GROUP	MODEL
BOD	2023MY
	K5 (DL3a)
NUMBER	DATE
322	November 2023

TECHNICAL SERVICE BULLETIN

SERVICE ACTION: TRUNK LID AND C-PILLAR GARNISH INSPECTION & REPLACEMENT (SA552)

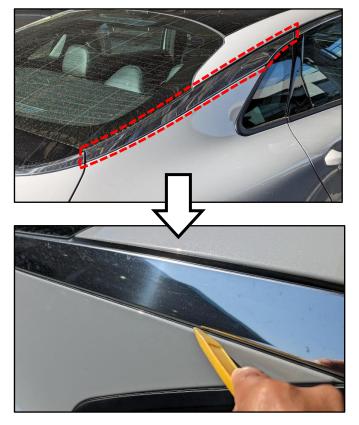
- Using a non-marring plastic trim tool, carefully pry 'light' upward pressure in <u>between the rear</u> <u>chrome trunk lid garnish rubber and the trunk</u> lid.
 - If the rear chrome trunk lid garnish <u>is</u>
 <u>not separated</u> (loose) when inspected
 (OK), then proceed to step 2.
 - If the rear chrome trunk lid garnish <u>is</u>
 <u>separated</u> (loose) when inspected
 (NG), then refer to the rear trunk lid garnish by referring to the 'Replacement Procedure' on page 3, and proceed to step 2.

- Using a non-marring plastic trim tool, carefully pry 'light' upward pressure in <u>between the rear</u> C-Pillar chrome garnish rubber and the body.
 - If the rear chrome C-Pillar garnish <u>is</u>
 <u>not separated</u> (loose) when inspected
 (OK), then no further action is required
 unless the rear trunk lid garnish
 requires replacement.
 - If the rear chrome C-Pillar garnish <u>is</u>
 <u>separated</u> (loose) when inspected
 (NG), <u>then replace the rear trunk lid</u>
 <u>garnish</u> by referring to the
 'Replacement Procedure' on page 4.

Replacement Procedure: (Trunk Lid Garnish)

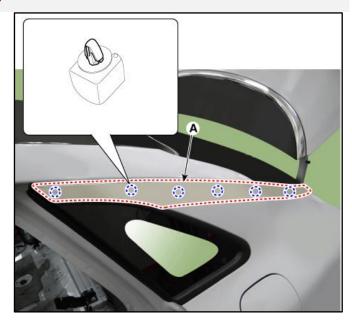
Remove the rear trunk lid garnish (A) by referring to "Body (Interior and Exterior) → Body Side Molding → Trunk Lid garnish → Repair Procedures" in the applicable Shop Manual in KGIS.

Carefully remove the trunk lid garnish. The 'new' trunk lid garnish 'gloss black' trim DOES NOT come painted. Be extra careful not to scratch/damage when handling. If it is damaged, the new part will need to be painted to match and require additional DPSM approval.

- 2. Carefully place the removed rear trunk lid garnish face down over a clean cloth to protect the gloss black painted surface.
- 3. Loosen the eight (8) chrome trim retaining screws (X).
- 4. Using a flat head screwdriver, detach/unlock the eighteen (18) locking tabs to detach the chrome trim from the gloss black trim.

The removed black trim will need to be reused as only the chrome trim is being replaced.

- 6. Take the 'new' chrome trim and attach to the 'original' removed painted gloss black trim.
- 7. Reassemble the trunk lid garnish in the reverse order of removal.
